ECE/TRANS/WP.29/GRRF/2008/14*
9 July 2008

REGULATIONS Nos. 13 AND 13-H (Braking)

Proposal for draft amendments to Regulation No. 13
(Braking)

Submitted by the expert from Germany **

FIGURE 1A

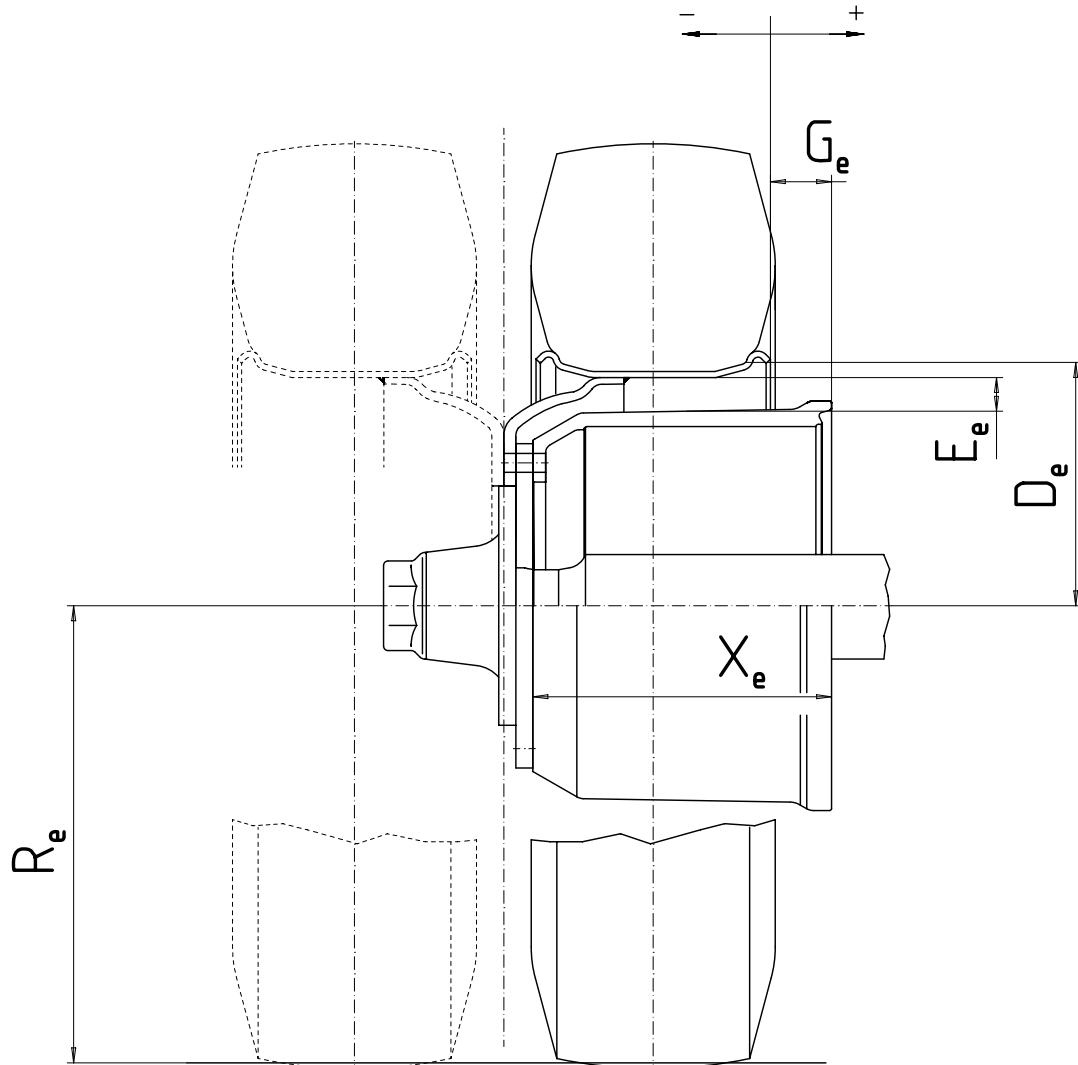
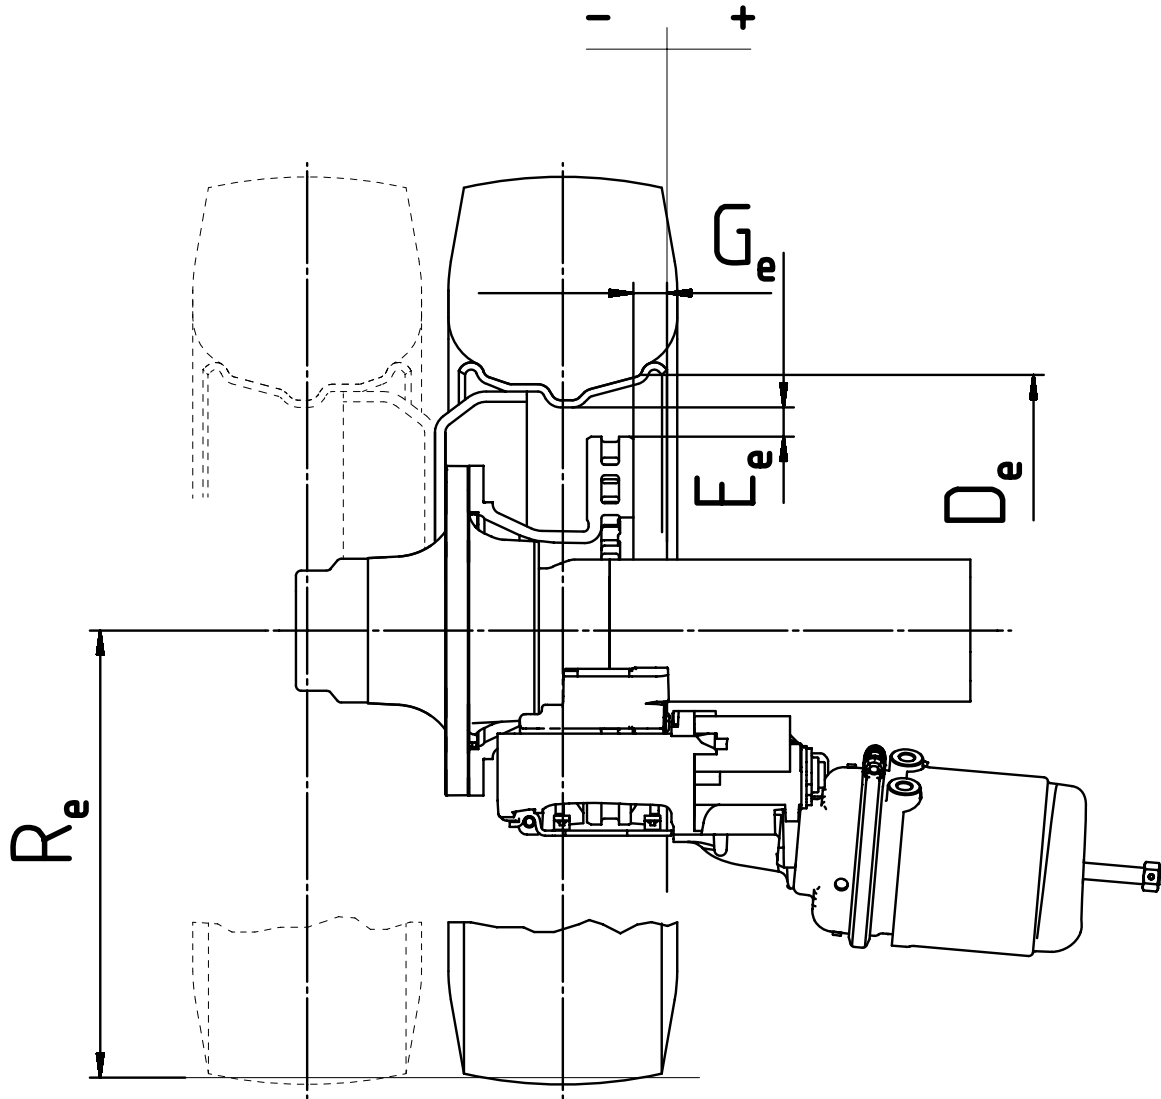
Annex 11, Appendix 5, figures 1A and 1B: dimension B_e deleted as not applicable. Symbol F_e replaced by G_e . – Dimension for D_e corrected. Plus and minus signs added for the dimension G_e .

FIGURE 2A

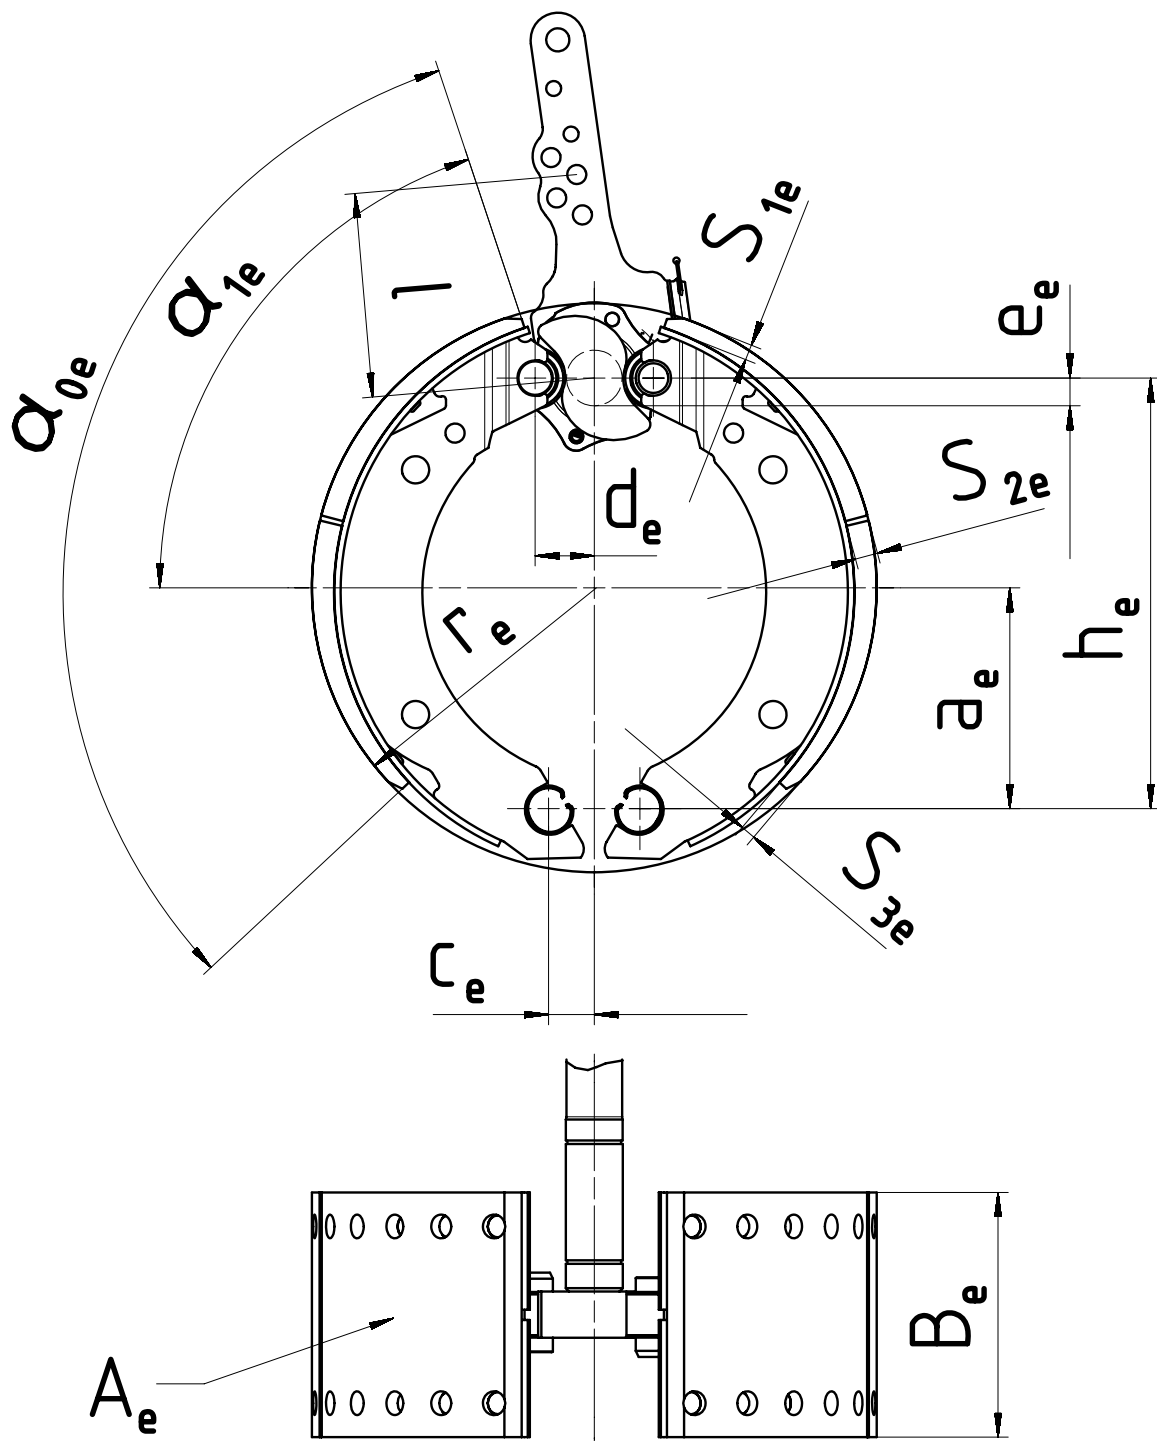
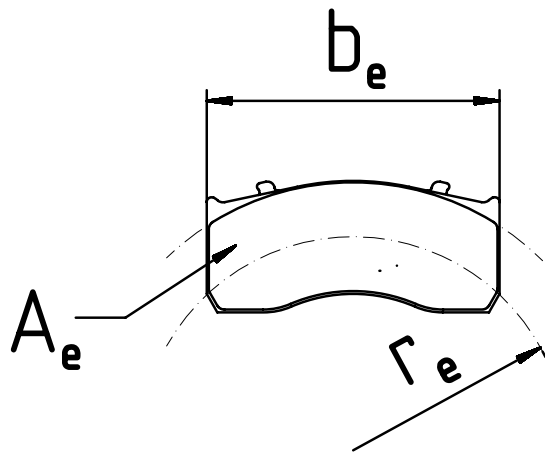
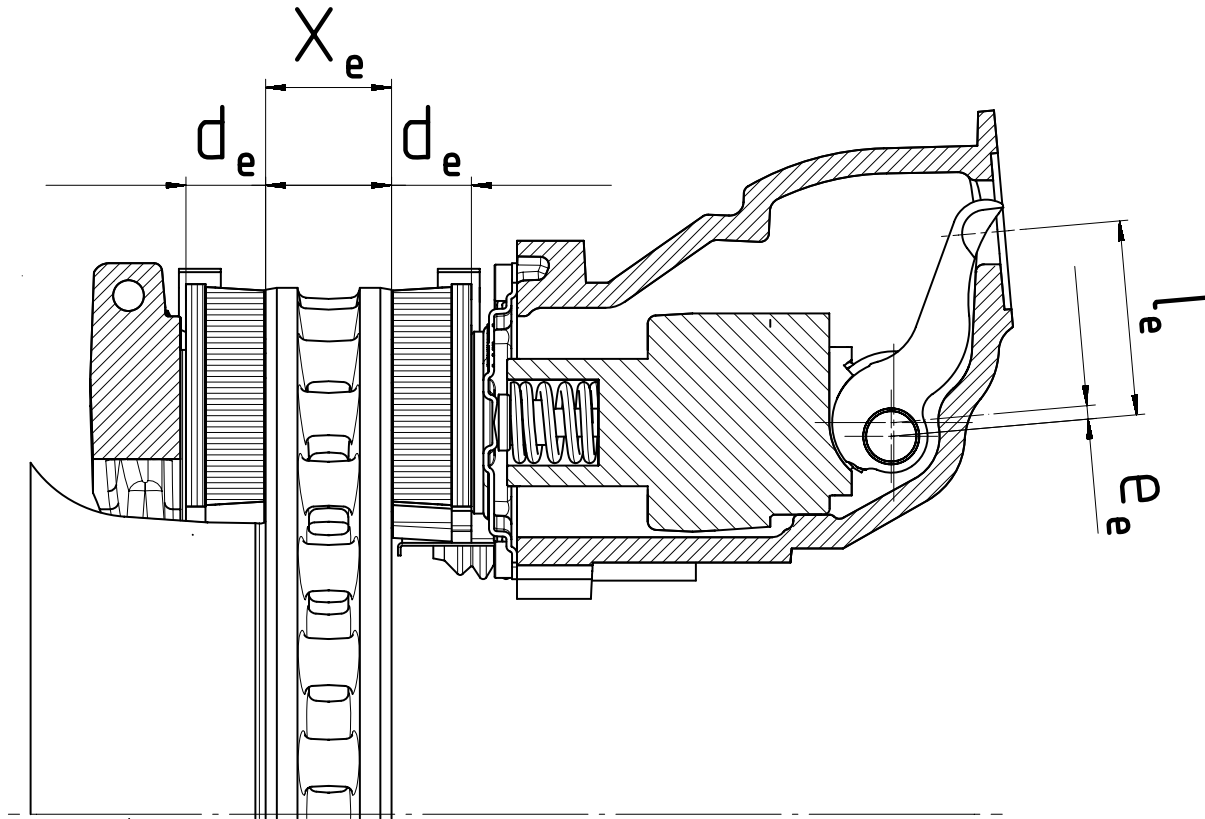
Annex 11, Appendix 5, figures 2A and 2B: Symbol F_e replaced by A_e .
